EDGERTON PLANNING COMMISSION AGENDA
REGULAR SESSION
Edgerton City Hall
August 11, 2015
7:00 PM

To: Edgerton Planning Commission
Fr: Kenneth Cook, AICP, CFM, Community Development Director
Re: FP2015-05 Final Plat for Logistics Park Kansas City – Southeast, Third Plat
Revised Plans Submitted 07-24-2015

To: Edgerton Planning Commission
Fr: Kenneth A. Cook, Community Development Director
Re: Application FS2015-04 for the Final Site Plan for Logistics Park Kansas City – Southeast, Third Plat (IP XV) – Revised Plans Submitted 07-24-2015

Requested Action: Final Site Plan – Logistics Park Kansas City – Southeast, Third Plat (Inland Port XV)

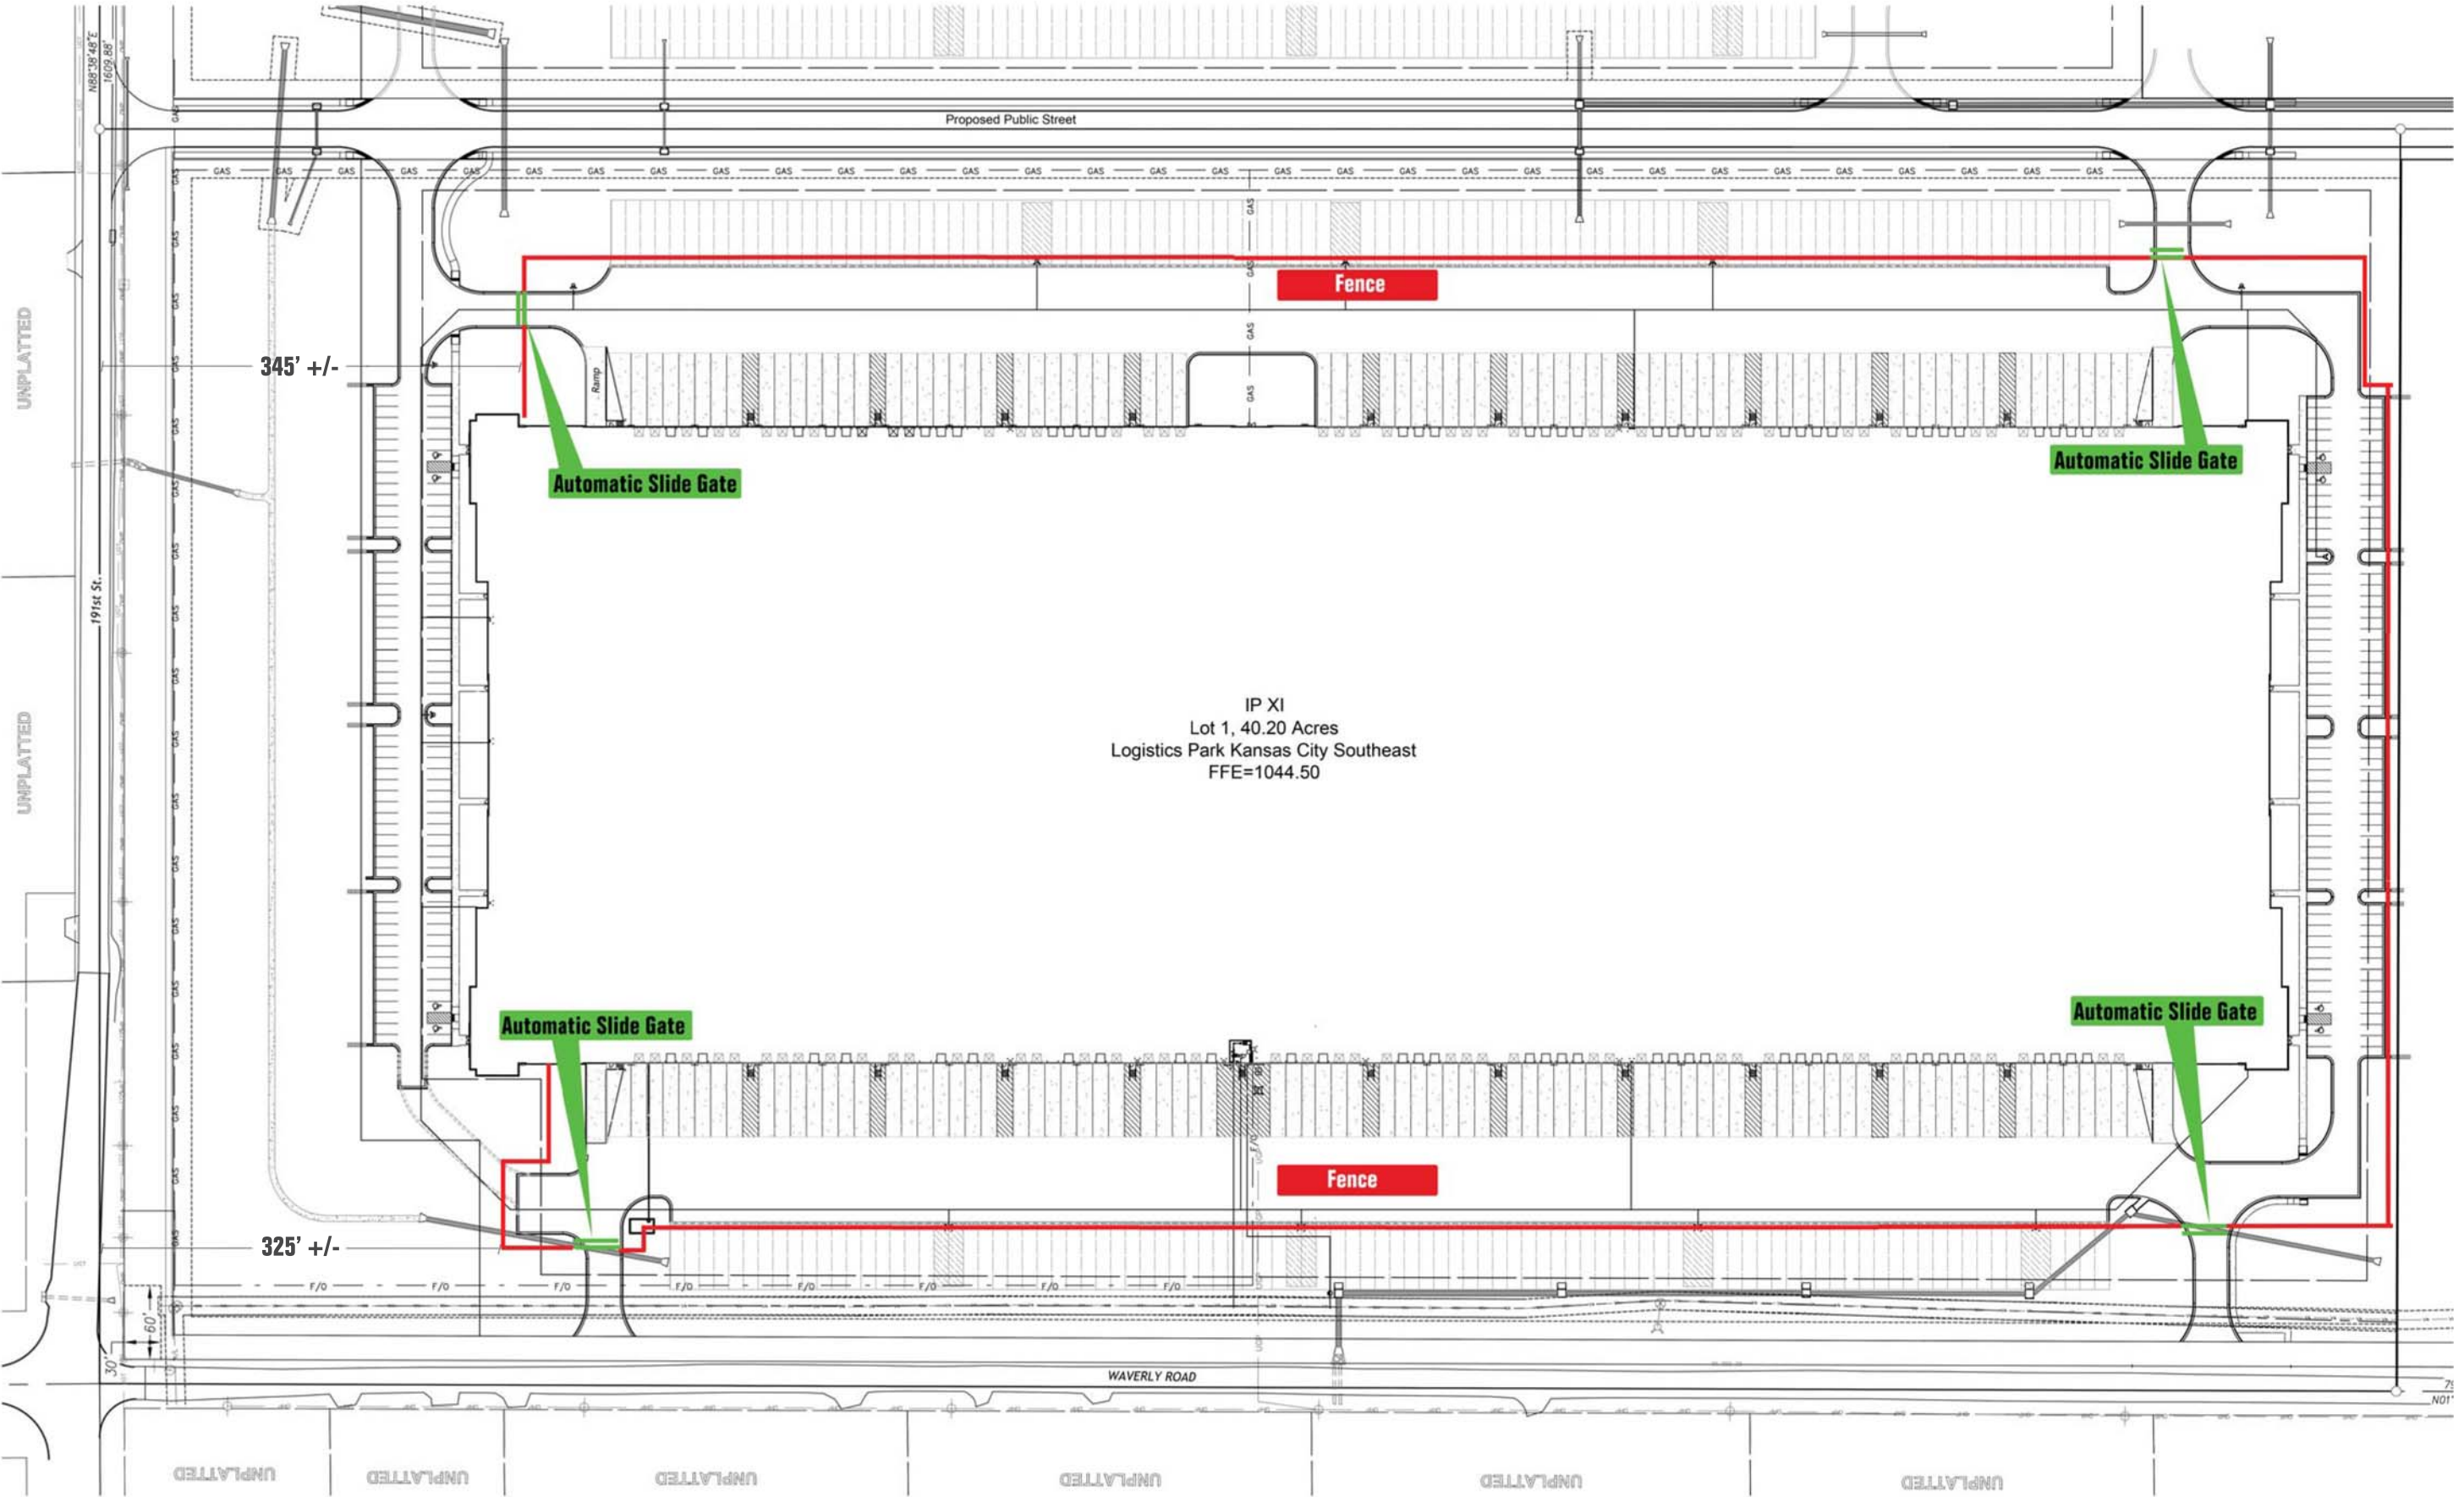
A C-TPAT fence system is required for Kubota's planned operations. Over the last several months, ELHC and Kubota management have worked through layout, flow operations, and security level requirements to serve the business needs for their Inland Port XI (IPXI) facility. The IP XI Kubota facility houses two independent business operations; Parts Distribution and Whole Goods Distribution. Each operation is seeking C-TPAT certification. Thus, requiring the entire facility to be surrounded by C-TPAT approved fencing and security gates.

ELHC and Kubota are proposing to use 1-in, black, vinyl-coated chain link fence, with a height of 8 feet. We anticipate this type and gate enclosures will be acceptable to the C-TPAT inspector. For reference, the C-TPAT approval is based on the inspector's recommendation versus a prescribed specification. A sample of the fence has been provided to the City. The requested placement to support the Kubota's operations of the fence is illustrated on the attached figure.

Noted on the illustration are the dimensions from 191st St. Evergreen trees will be located on each side of the north facing fence. Landscaping for the building and along 191st Street will be prepared in accordance with the Alternate Landscape Plan for LPKC SE, approved at the June Planning Commission hearing (attached for reference).

Final Plat for Logistics Park Kansas City – Southeast, Third Plat

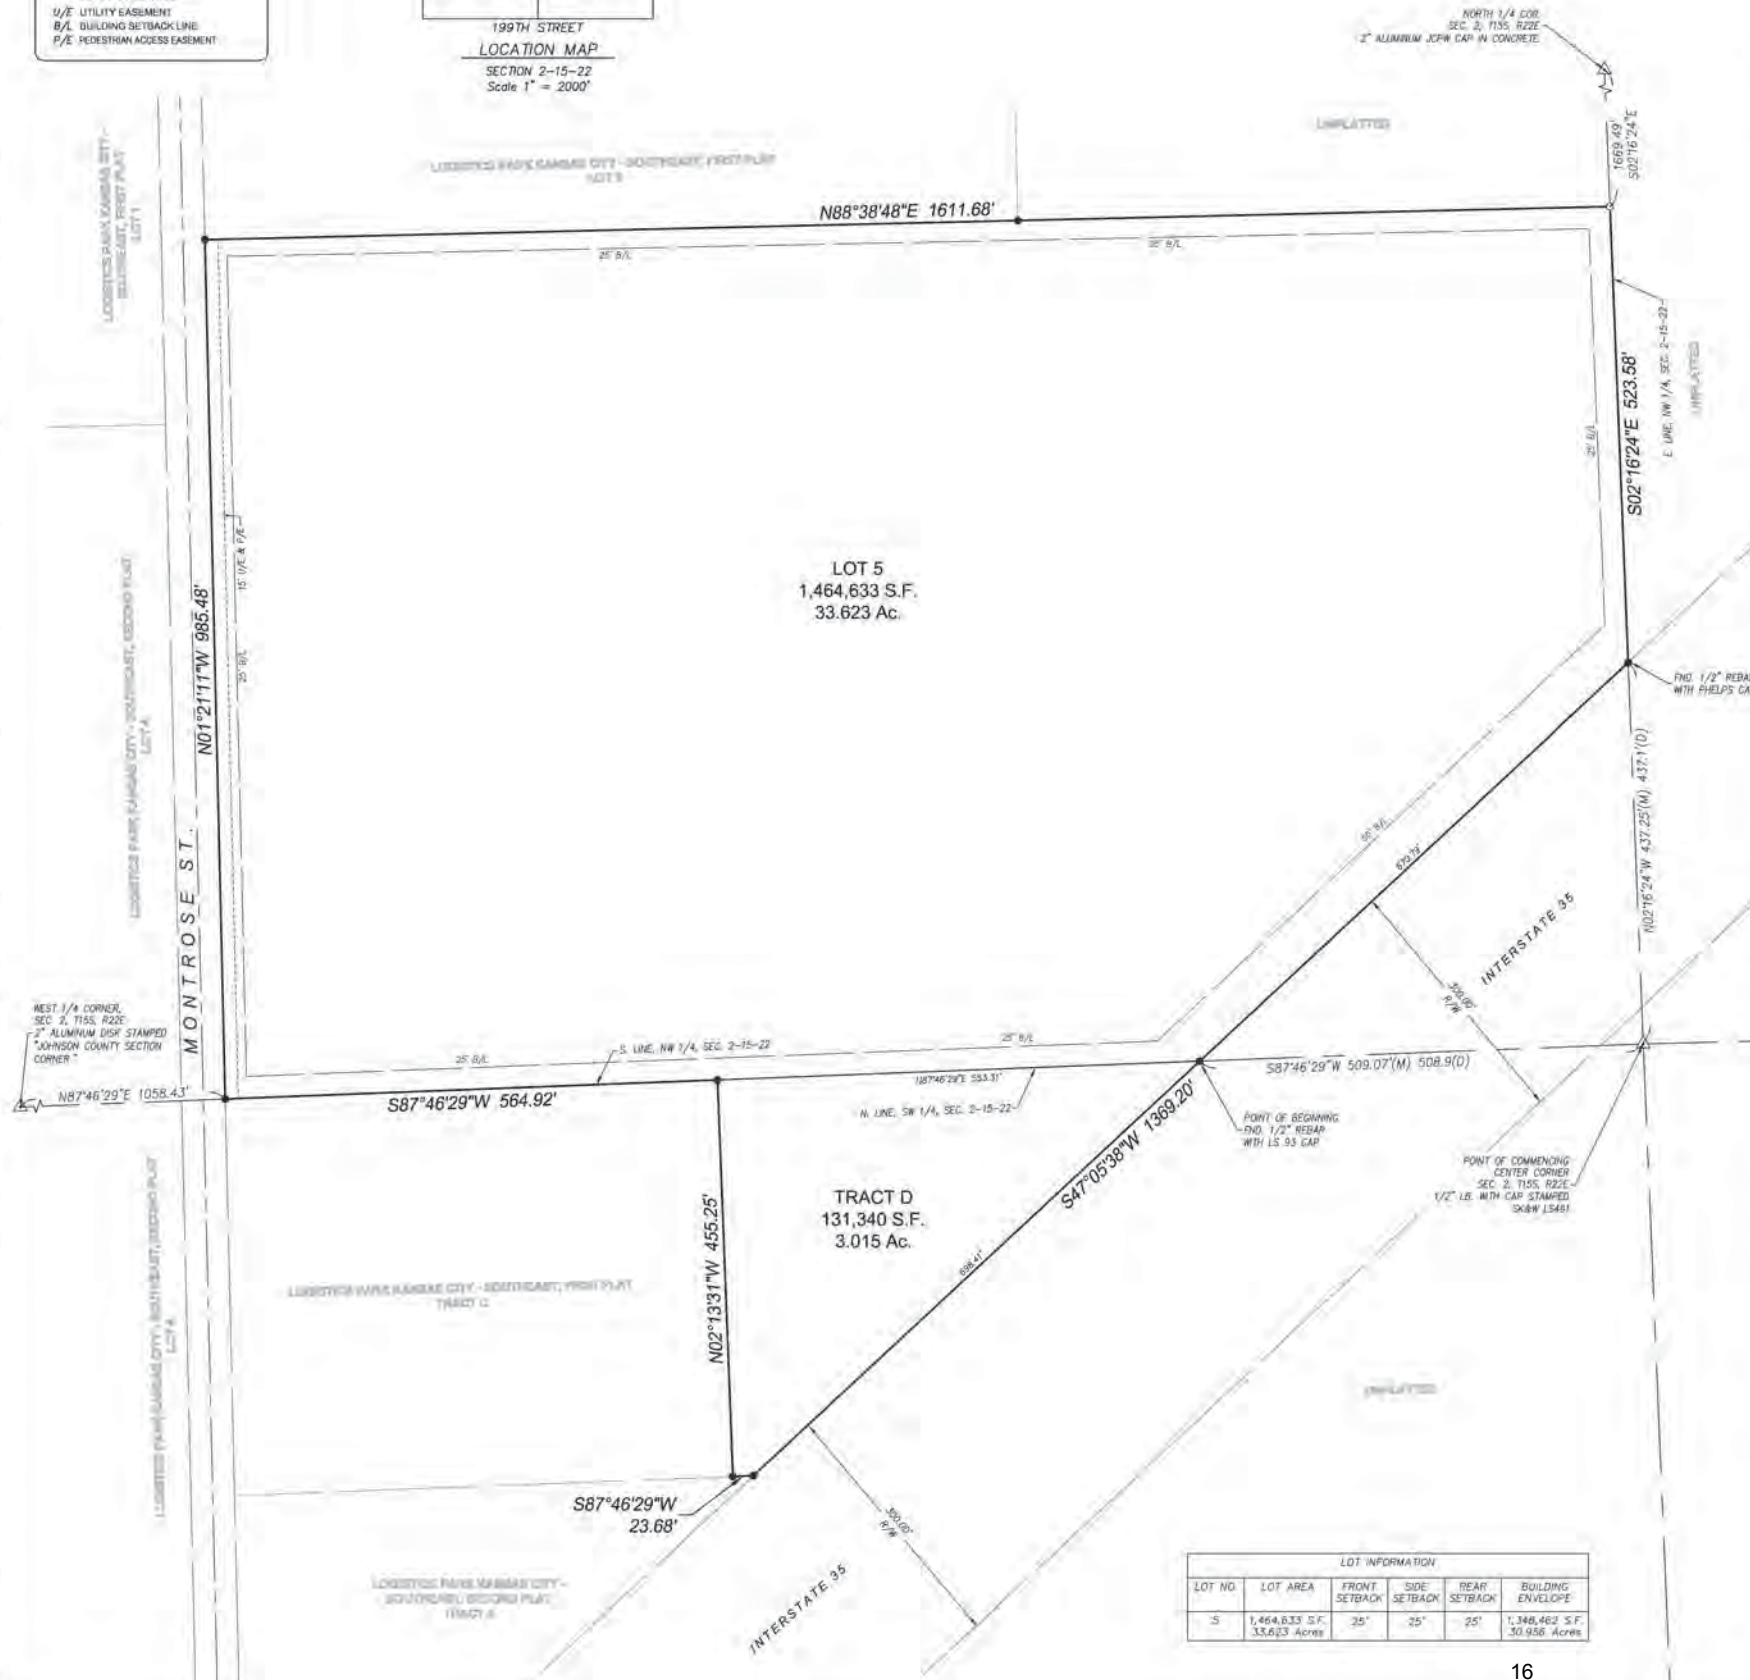
- ~~The text in the Restriction for the tract located in this plat needs to be updated to show the tract as Tract D. An extra space also needs to be removed following the word 'Association'.~~

- Additional wording needs to be added in the dedication which describes the access easement, who has a right to use it (all public or just the adjoining lots) and who is responsible for maintenance of the private drive. It may also be beneficial to have some type of agreement filed that describes who is responsible for maintenance and use the drive.

- The previous plan had shown a possibility that a parking area may extend onto the Northern portion of this tract adjacent to Lot 2. Kansas Gas made comments about the need to add a utility easement in this area, and the applicant has made this change. The current plan shows a utility easement being located in the area that was originally shown as possible parking. Should the location of this easement be adjusted so that it would run through a green space in case the parking is ever needed in the future for this area?

- ~~The dimension of the Southeast boundary line of the tract (Interstate 35 ROW line) does not match the dimension in the written legal description. It appears that the dimension on the drawing is correct based upon the calculation using~~

OVERALL GRADING PLAN

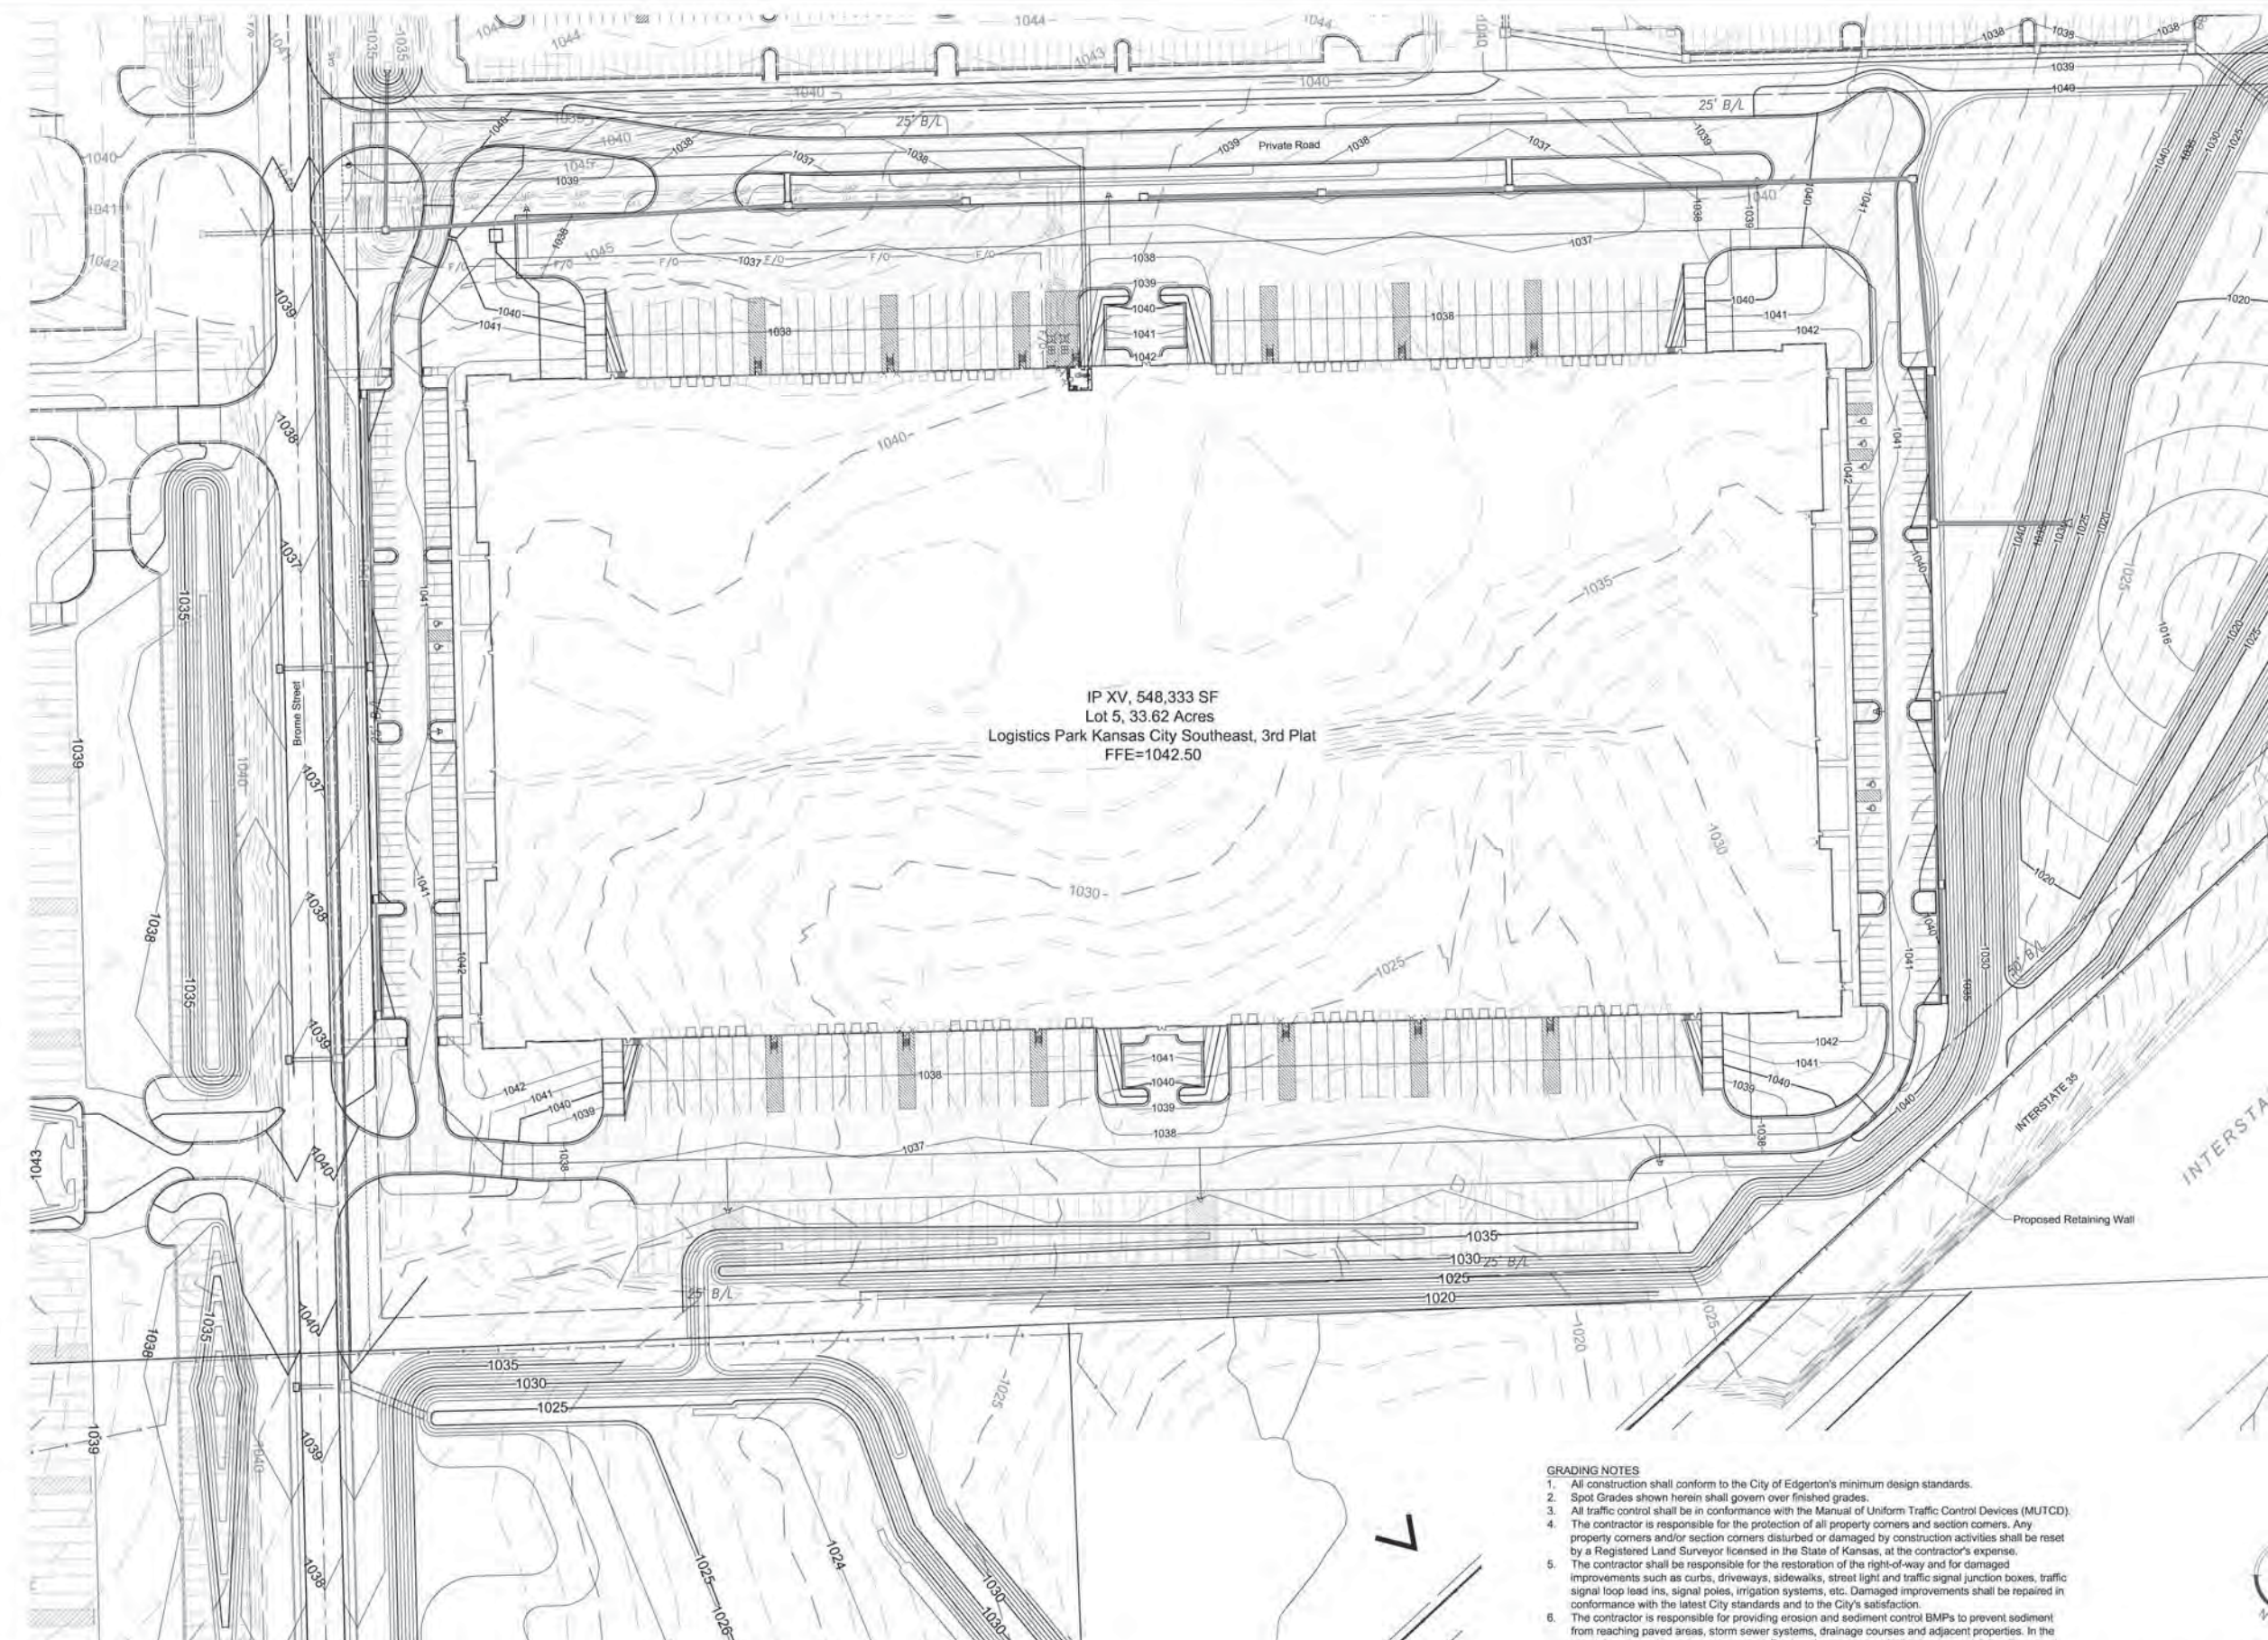
~~private road that will be shared with Inland Ports XII & XIII.~~ **Final Site Plan Complies.** **The Grading Plan refers to Brome Street instead of Montrose. Update Final Site Plan.**
